Docket Item #11
BAR CASE# 2005-00105

BAR Meeting
May 25, 2005

ISSUE: Concept Approval - alterations and alterations

LOCATION: 1210 Queen Street

Figure 3 - Rear (south) elevation

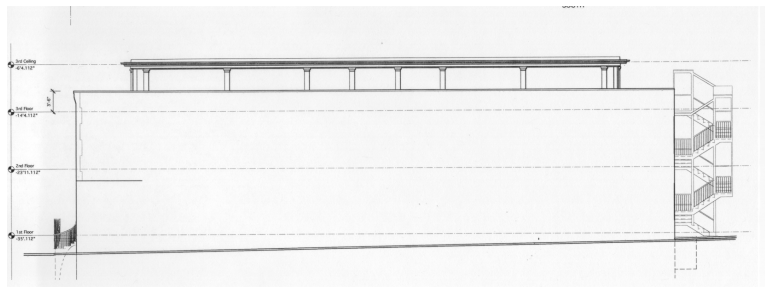
Staff notes that the front elevation of the addition is slightly asymmetrical, with the two windows on the right smaller than those on the left and only one pilaster on the left where there are two on the right. Given the strictly symmetrical design of the historic building, Staff believes the front elevation of the addition must be symmetrical as well.

This 86' long wall will be visible from numerous vantage points. Having no openings it has the potential to be oppressive. Staff is concerned that as much attention be given to this elevation as to the east elevation. The concept plans show pilasters arrayed along the facade. This device may prove to be adequate, but as shown it appears insufficient.

- 1) That the roof of the addition be flat;
- 2) That there be no thru-wall air conditioning units;
- 3) That the HVAC units be located on the west side of the third story roof deck;
- 4) That the front elevation of the third story addition be symmetrical and,
- 5) That the west elevation be thoughtfully designed to provide visual relief for the long wall.
